PREVOST

**SAFETY
RECALL**

Sr12-19

DATE : JULY 2012	SECTION : 14-STEERING
SUBJECT : REPLACEMENT OF STEERING GEARBOX MOUNTING BOLTS

**AFFECTED STEERING GEARBOX
SUPPORT FOUND ON X3-45 COACHES**

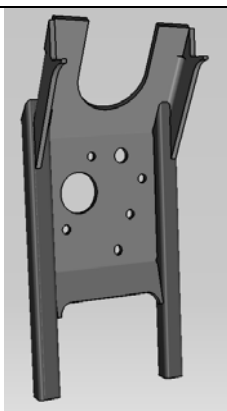
The steering gearbox mounting bolts found on the involved vehicles are too long to be used with the steering gearbox support design installed on the involved vehicles.

Too long bolts will reach the bottom of the blind holes found on the steering gearbox before a sufficient clamping force is created to maintain the steering gearbox properly fastened on its support. Bolts may be insufficiently torqued.

With the passing of time, the steering gearbox bolts may start to loosen, leading to reduced steering function, thus increasing the risk of a crash.

1. Unscrew and discard a first steering gearbox mounting bolt and washer.
2. Replace that bolt and washer using bolt #5001442 and a flat washer #611044. Apply blue Loctite 243 on bolt threads and tighten to a torque of **385 lbf-ft**.
3. Repeat the previous steps for the second bolt and so on up to the fifth bolt.
4. Finally, apply an anti-corrosion compound on bolts head and washers.

**AFFECTED STEERING GEARBOX
SUPPORT FOUND ON H3 VIP**

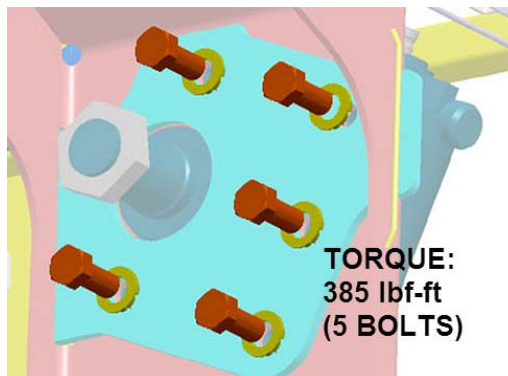
In order to maintain steering gearbox in proper position, replace mounting bolts one at a time.
